# MICE Hall – South Mezzanine

Jason Tarrant - STFC

- Contents
  - » Device checks with current South Mezzanine
  - » South Mezzanine change summary
  - » Conclusion

- AFC

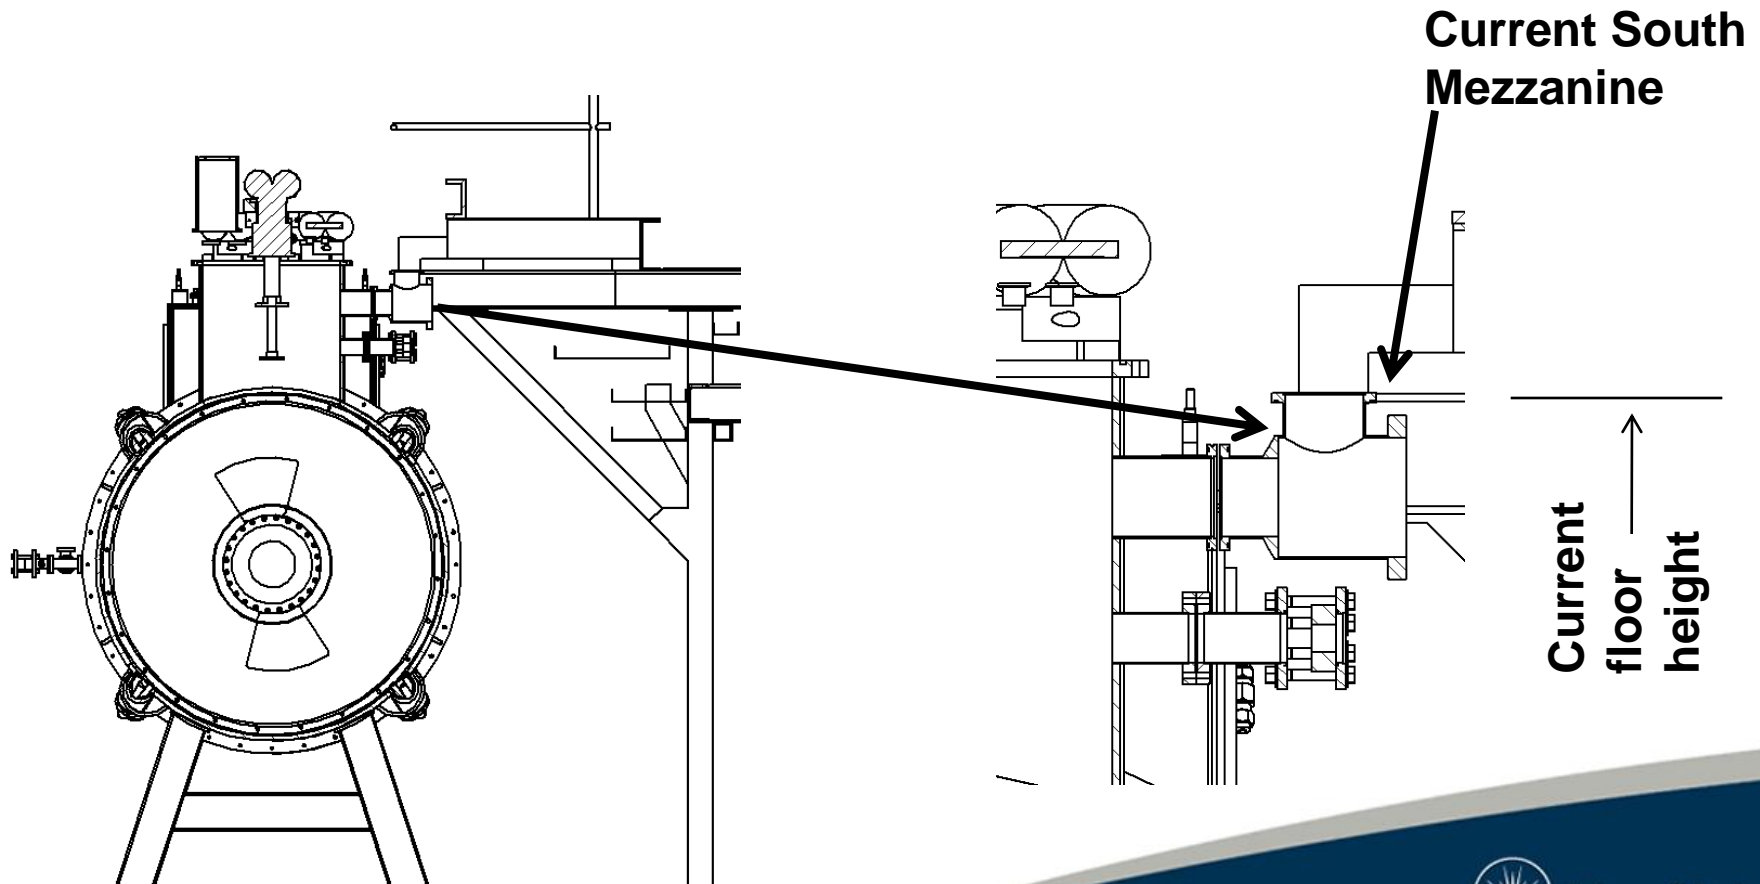
- » Hydrogen Safety Vacuum Line port currently will clash with floor

- AFC

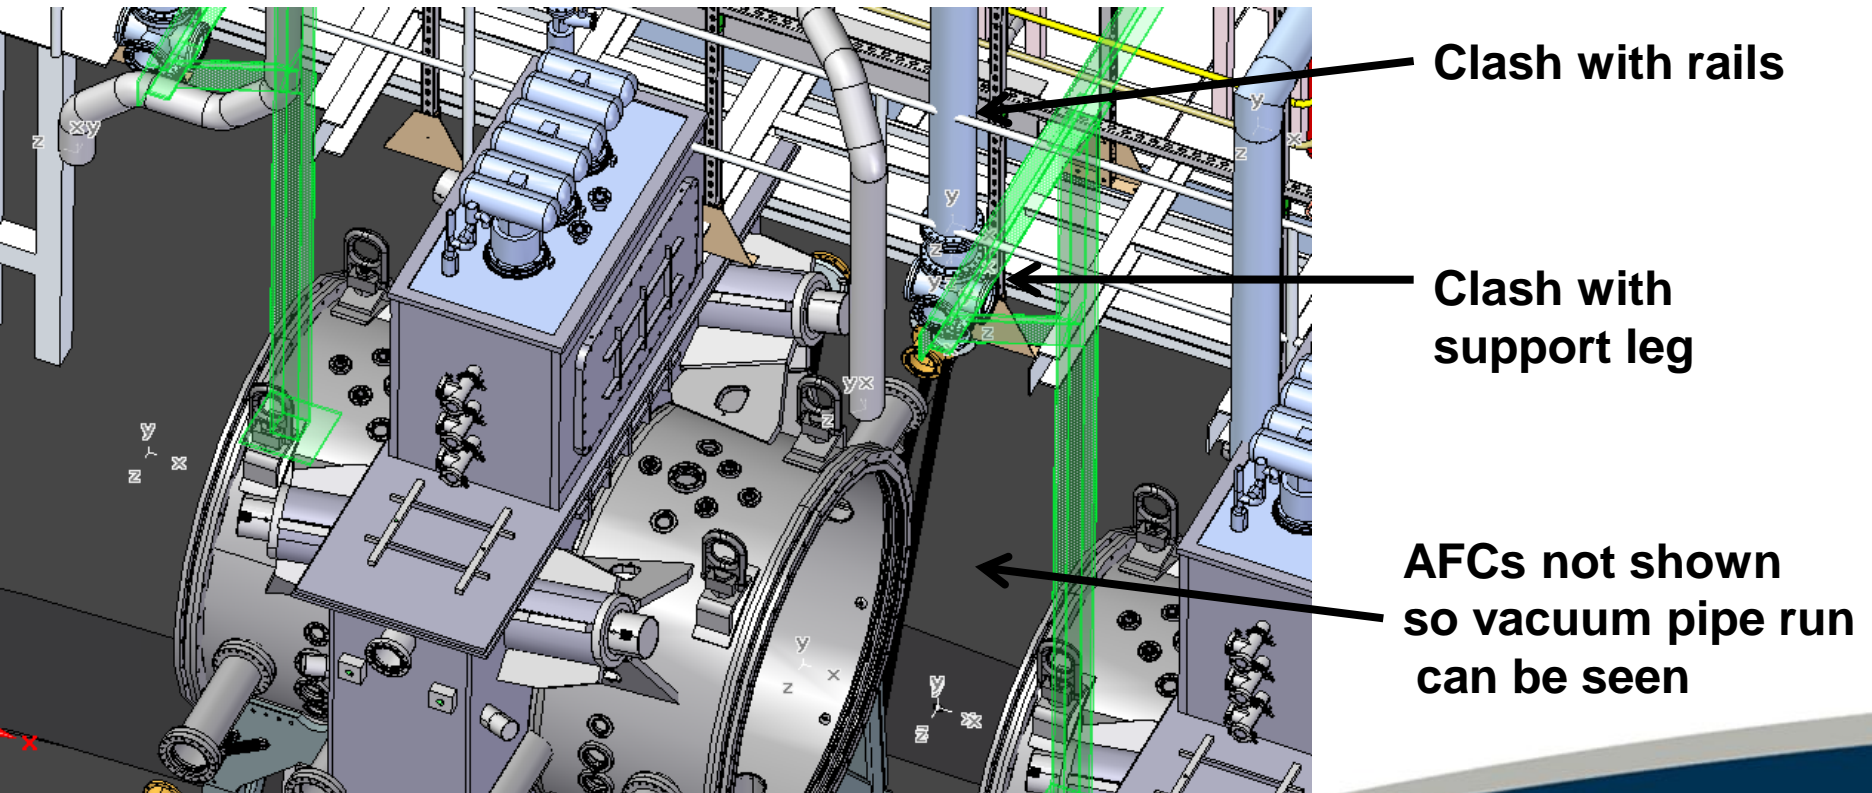
» Hydrogen Safety Vacuum Line itself currently clashes with rails & support leg

## AFC

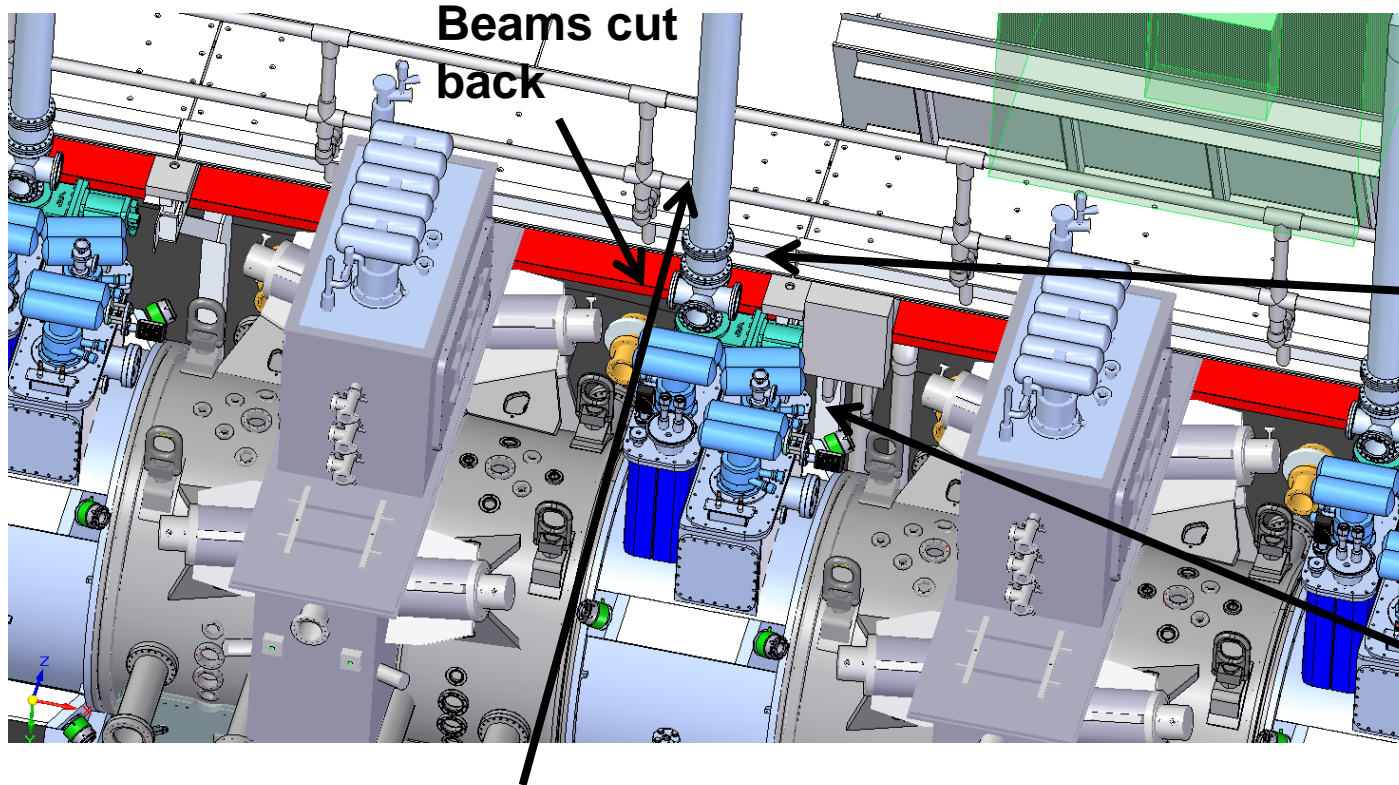
» Raise platform, move support leg & cut beams back to resolve

Raised & shortened floor section (hinged)

Support leg moved to next beam

'joggle' required in handrail around vacuum pipe

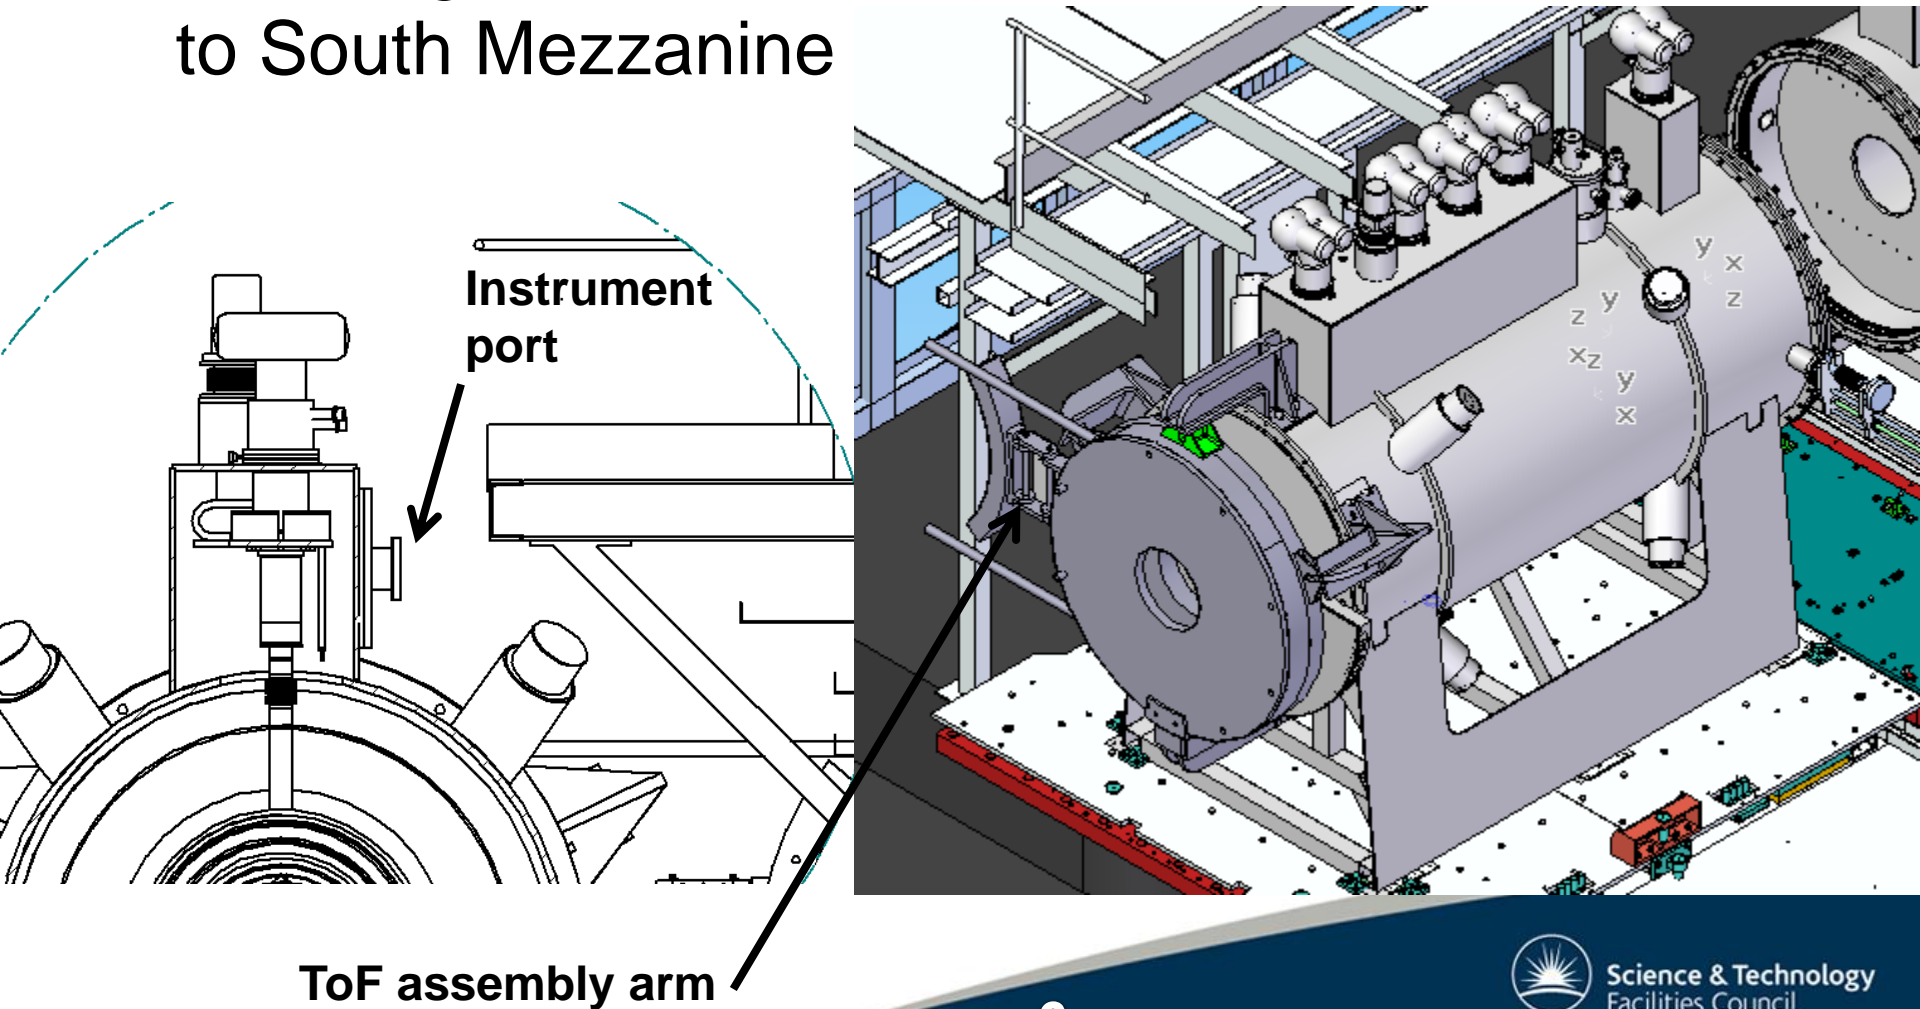
- Spectrometer Solenoid
  - » ToF Cage & instrument port close to South Mezzanine

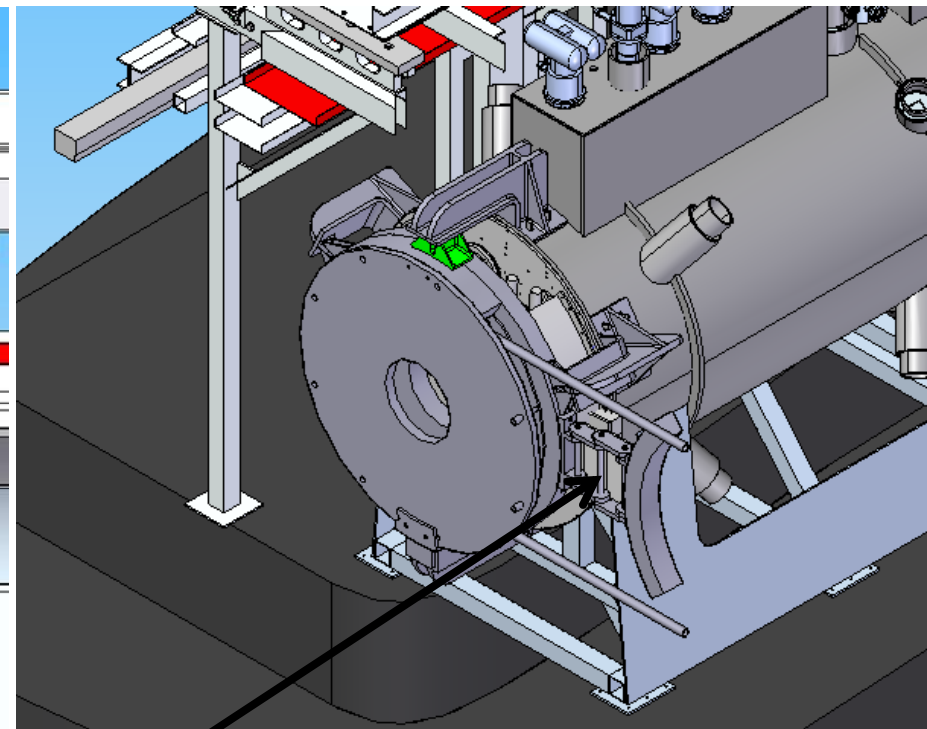
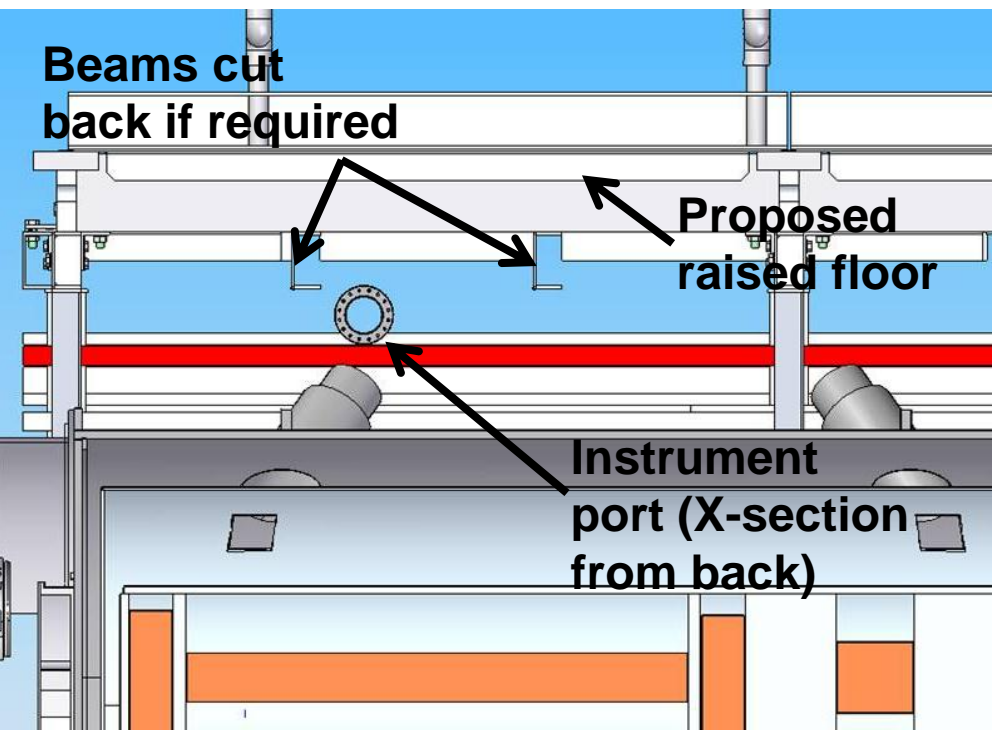
- Spectrometer Solenoid
  - » Rotate / mirror ToF arm & raise platform

ToF assembly  
arm

- RFCC

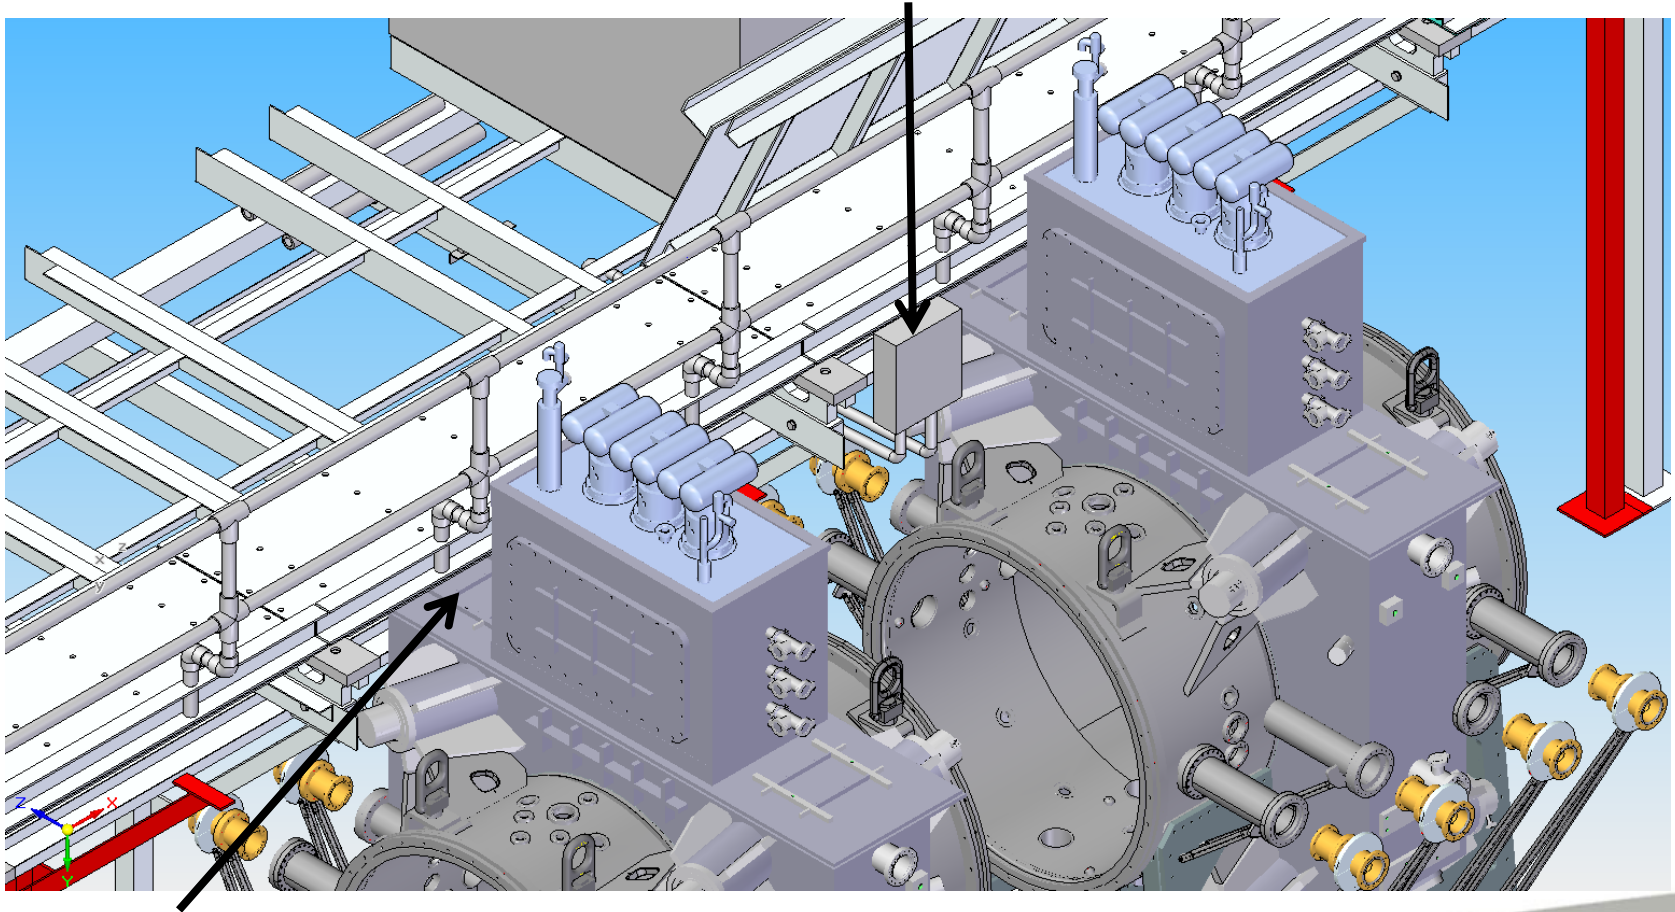
Water pipe  
& panel move

Mezzanine raised  
up over RFCC

- EMR

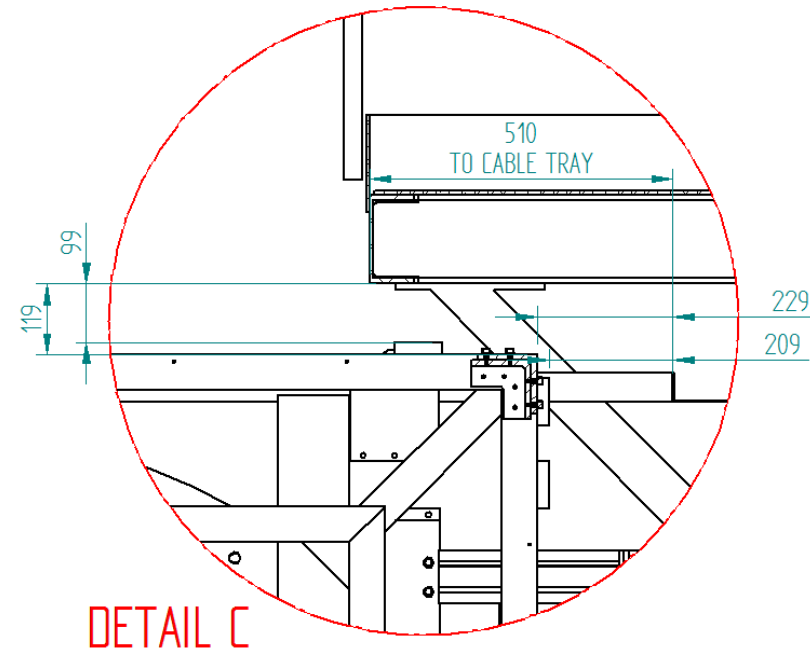
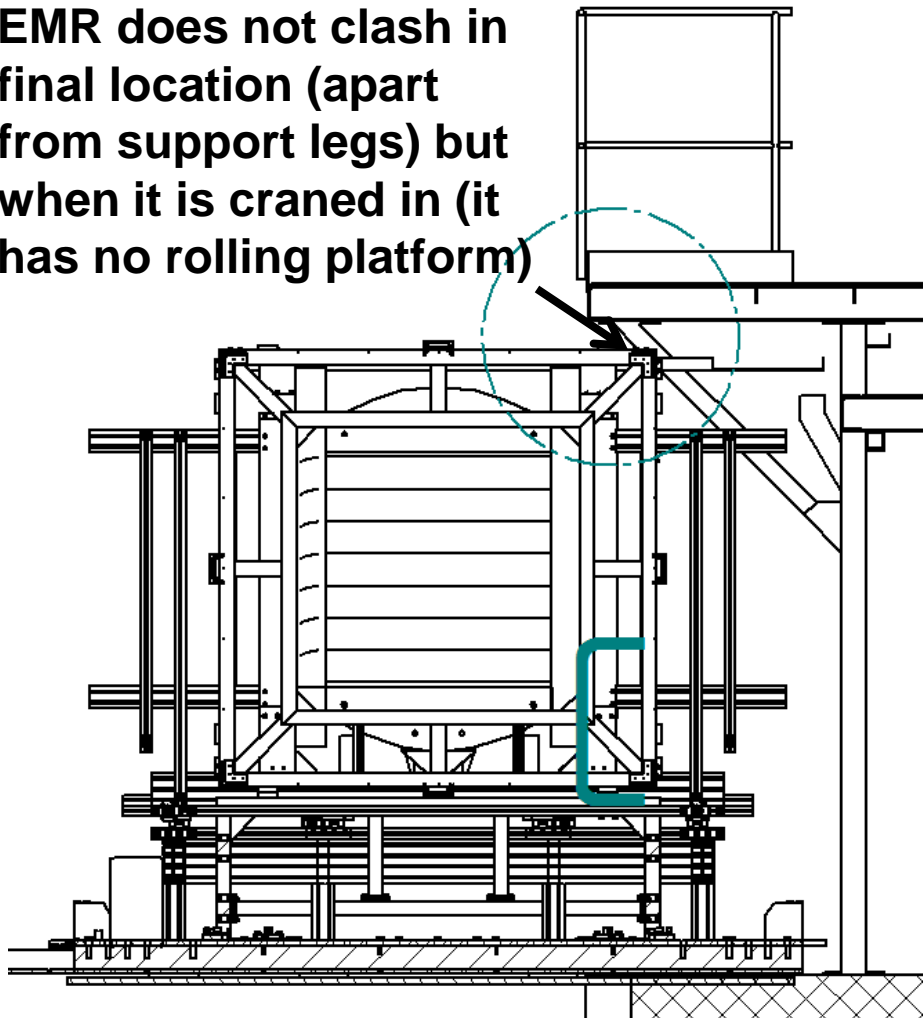
EMR does not clash in final location (apart from support legs) but when it is craned in (it has no rolling platform)

- Mezzanine & EMR

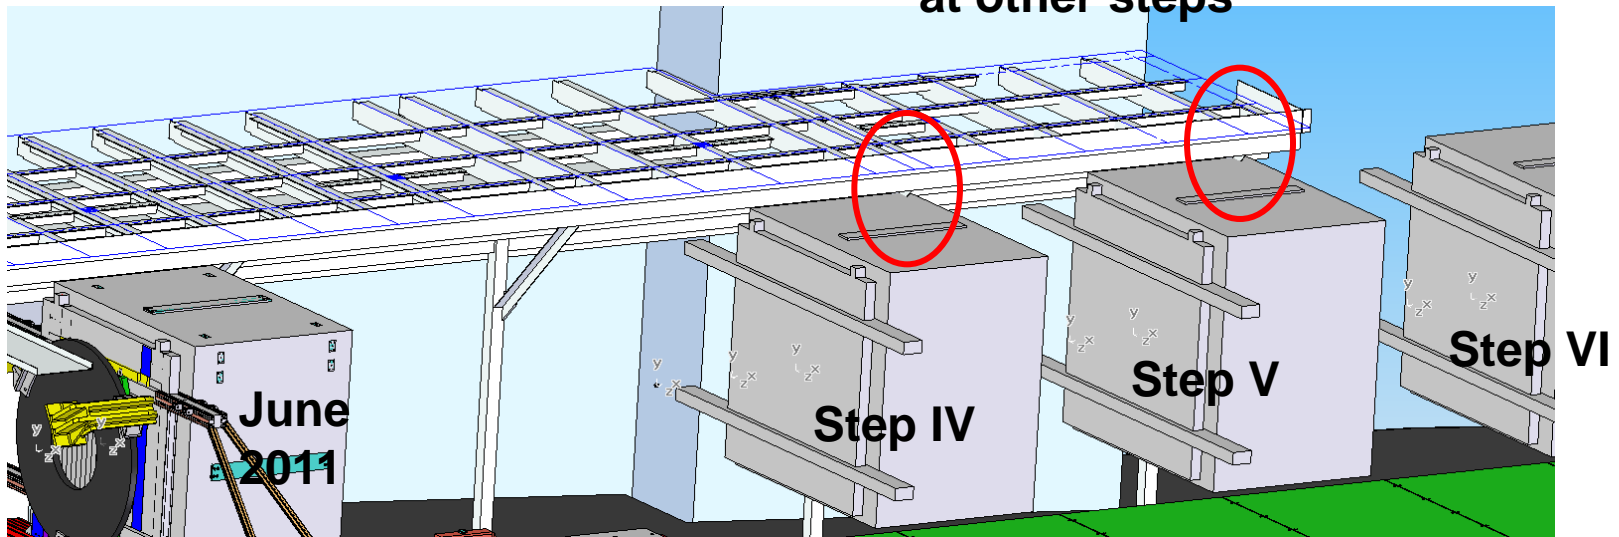
Potential clash  
with support pillars  
at other steps
